New firmware release

PLS_51_24_11.1

For the HP Latex 700 / 800 printer series

March 2024

New plastic needles maintenance workflow

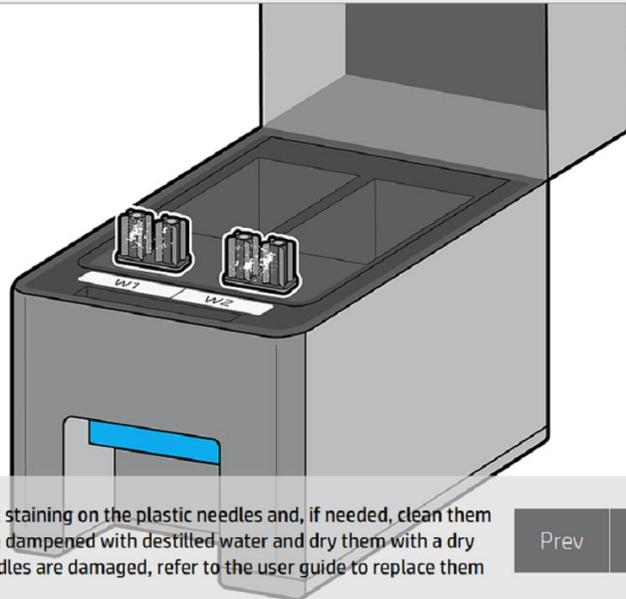
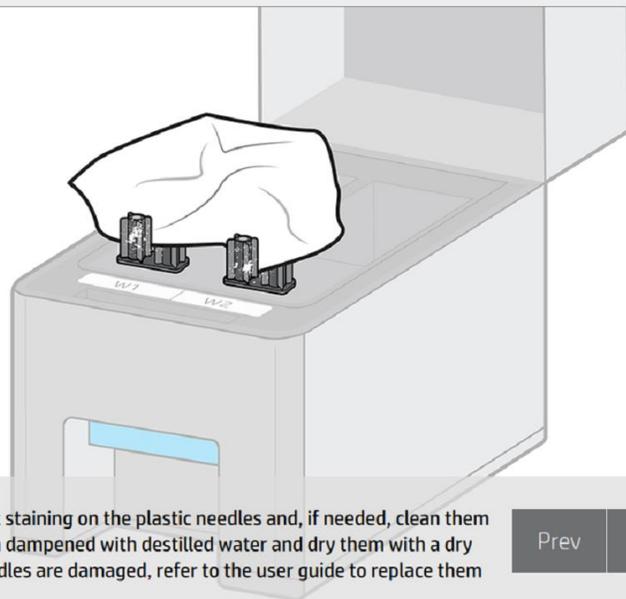
The message and the workflow of the slides on the front panel have changed to avoid unnecessary plastic needle replacement. These needles should only be replaced when they are broken.
